DS-K1T680 Series MinMoe Terminal Release Note (2021-11-18)

Device Model: DS-K1T680D(F)-E1 DS-K1T680D(F)W DS-K1T680D(F)G DS-K1T680D(F)G1 Naming Rule: D for M1 card, Desfire card, Felica card E1 for POE, W for Wi-Fi, F for fingerprint G1 for 3/4G, supported in Australia, Taiwan (China) and Latin America; G for 3/4G, supported in Europe, the Middle East, Africa, India, and Most Areas of Asia-Pacific (excluding Japan and Taiwan (China))	Firmware Version	ARM : ACS_680_AI3_EN_ STD _V3.2.33_build211116 ACS_680_AI3_EN_ NEU _V3.2.33_build211116
	SDK	Latest version
	iVMS-4200 Version	Latest version

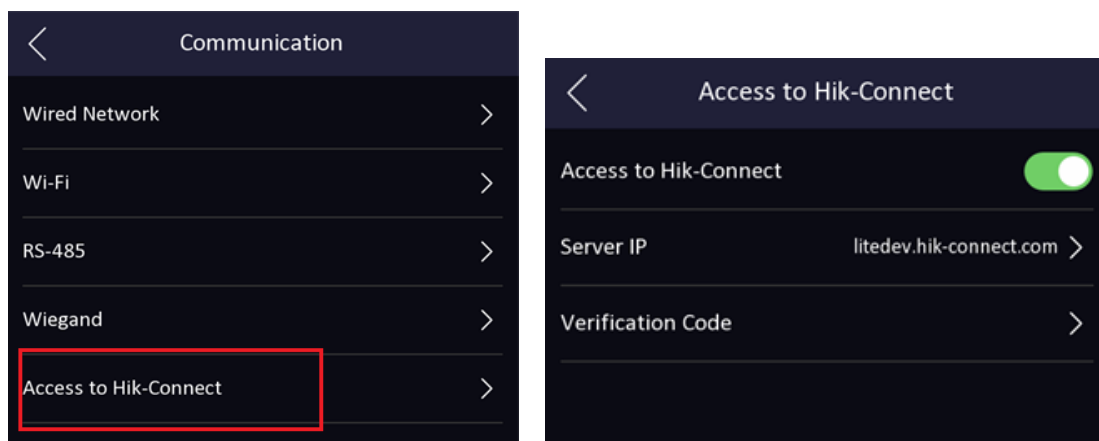
1. Fix the device offline issue caused by searching device event from iVMS4200 client through ISUP5.0 protocol;
2. Fixed some issues about ISAPI protocol.
3. Optimize the connection with HikCentral Professional platform;

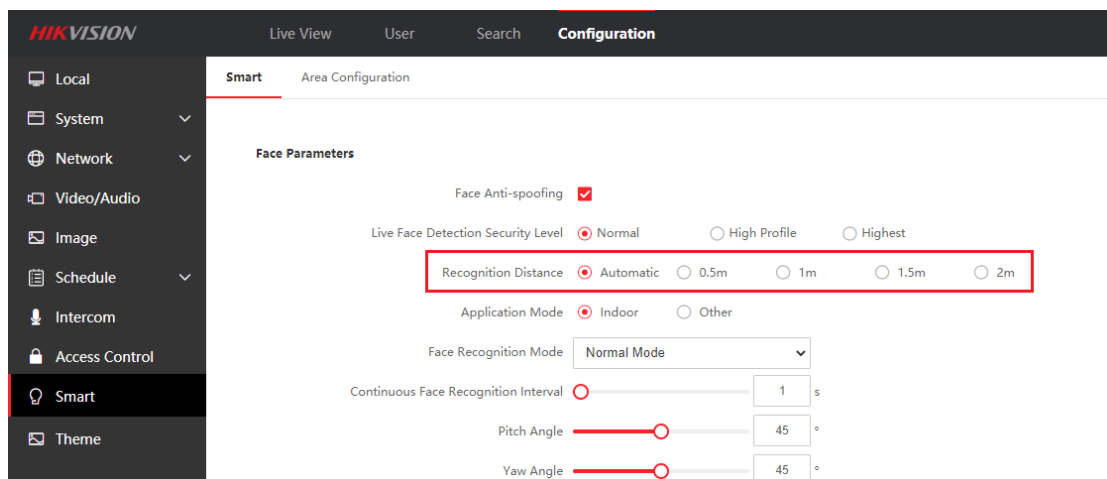
1. Add Hik-Connect menu in device UI Menu → Comm. The function is disabled in default.

1. Optimize the wake-up distance of the device screen through the face, and the wake-up distance is consistent with the recognition distance

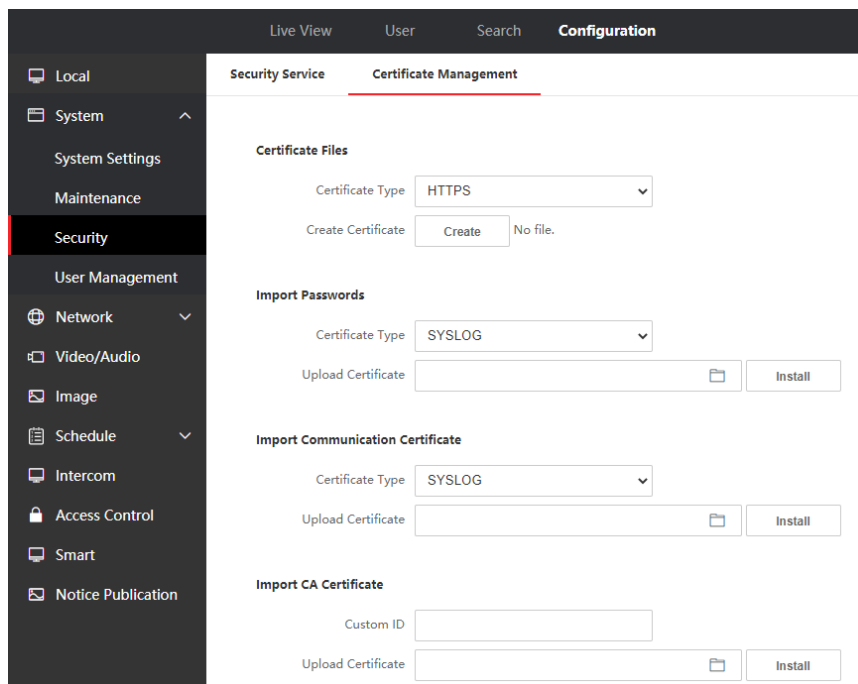
1. Support https feature

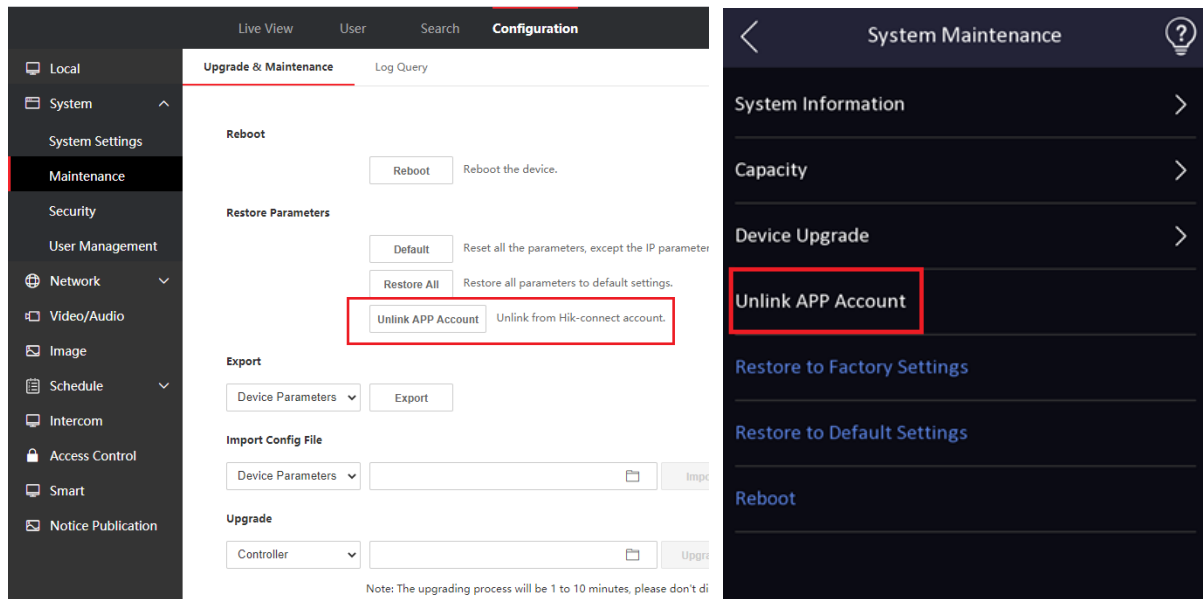
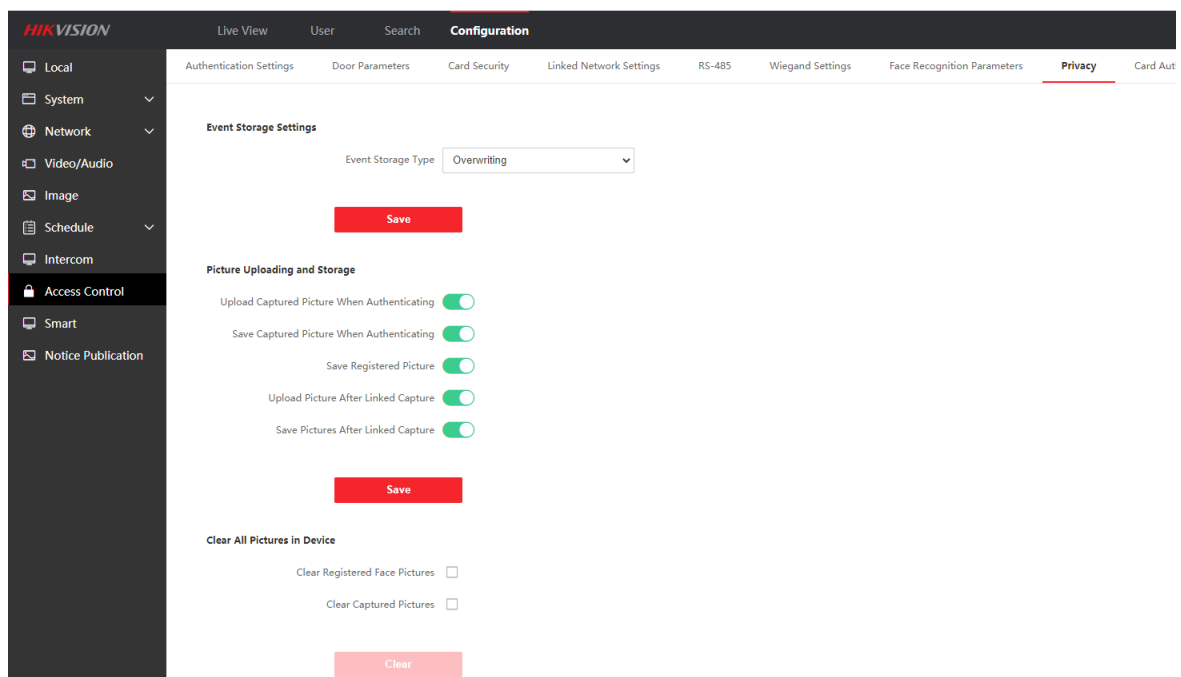
6. Support unbind device with hik-connect account on SADP tool, local UI and web

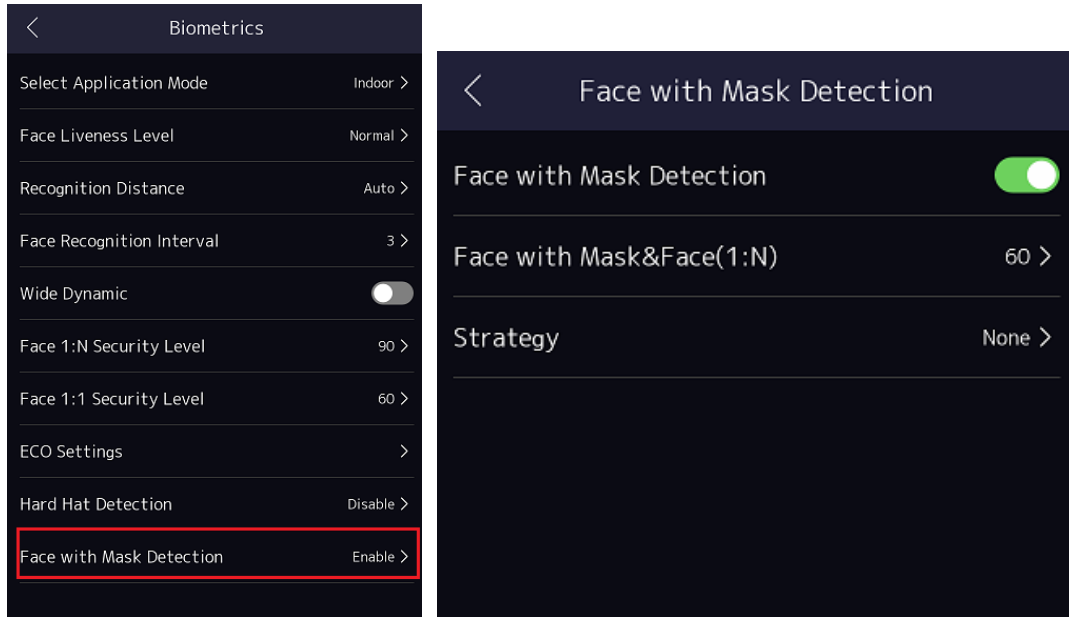
7. Add privacy protection, support event Storage Settings, Picture Uploading and Storage, Clear All Pictures in Device

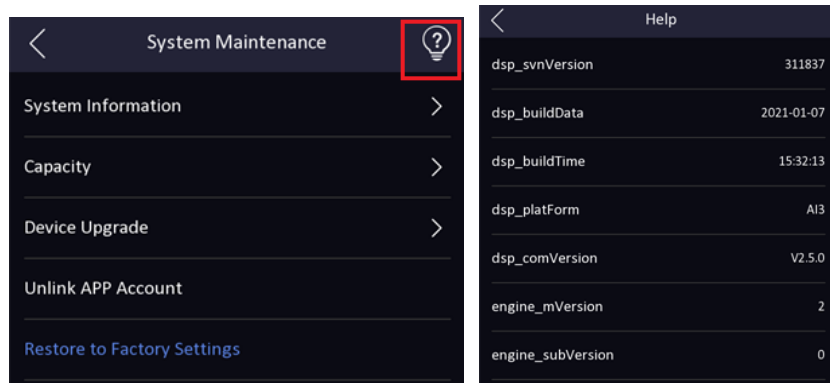
8. Add face mask detection function(enabled in default);

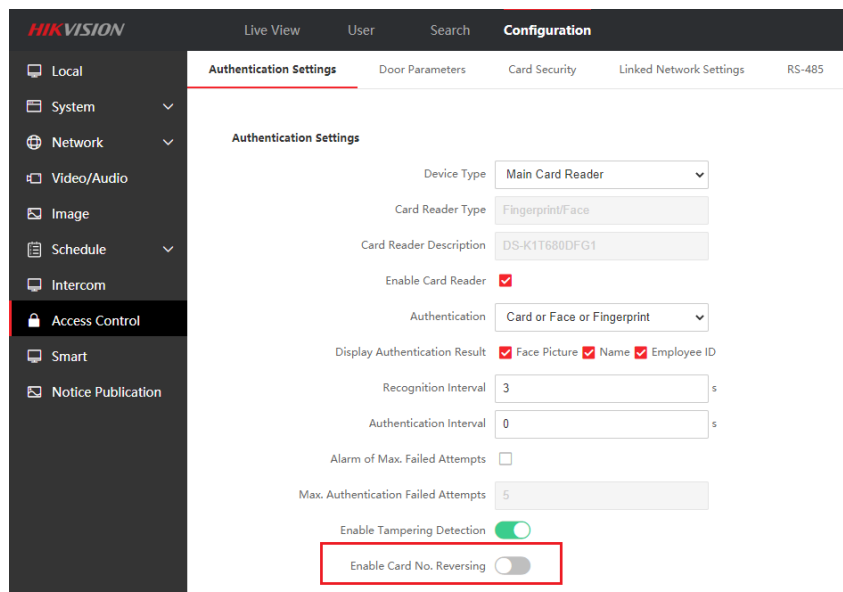
9. Add help interface to check system module version for technical support (long press for 3s).

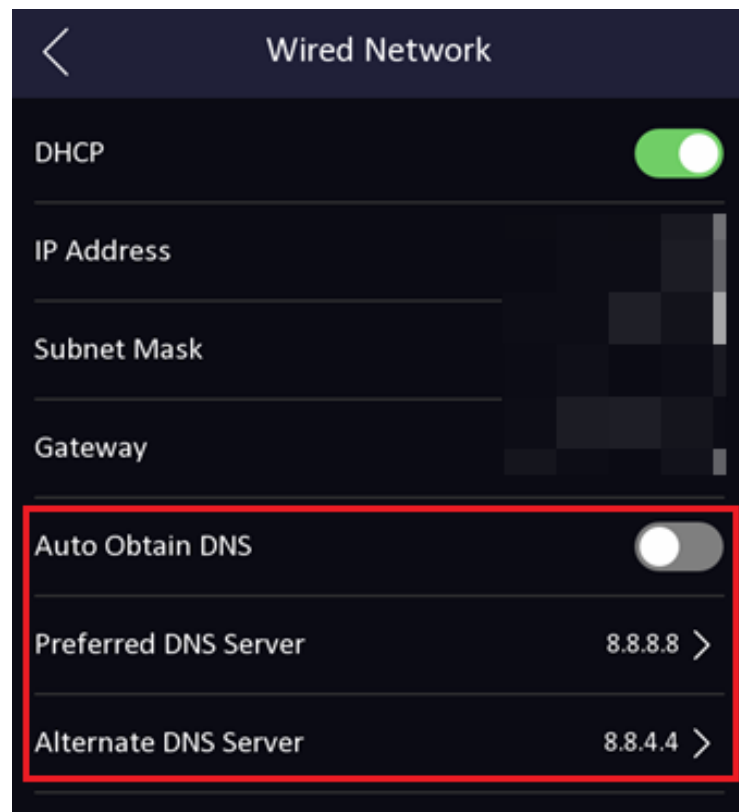
- Hik-Connect function is turned off in default for privacy protection, if customer want to manage device from App, please turn on manually in the web.

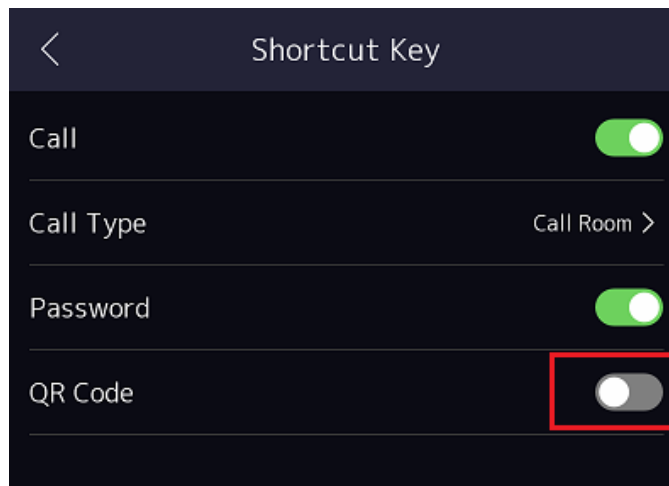
- DNS can be configured from device UI in menu → Comm.-->Wired Network

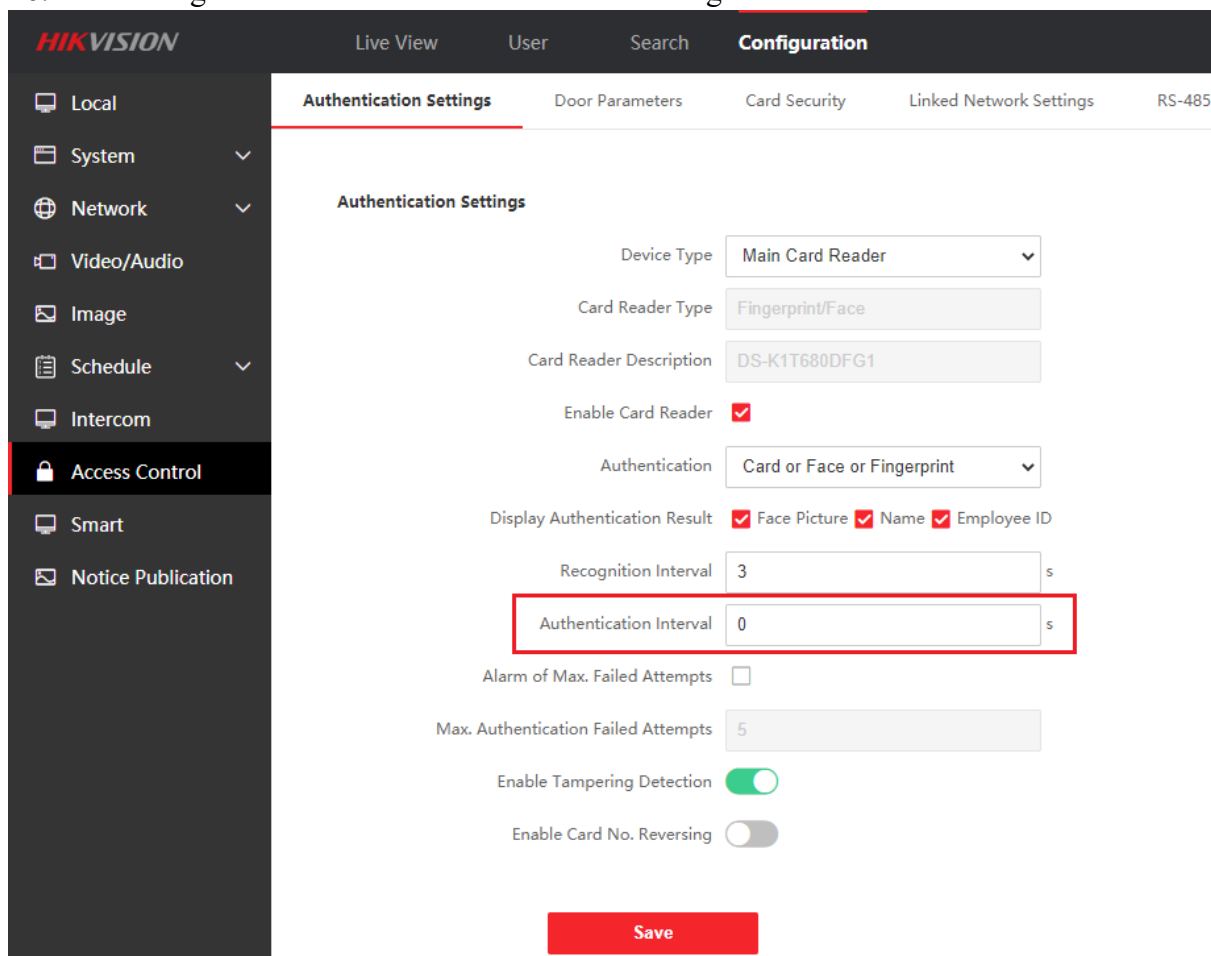
- After disable QR code shortcut from the menu, device will support QR code and face verification at the same time.
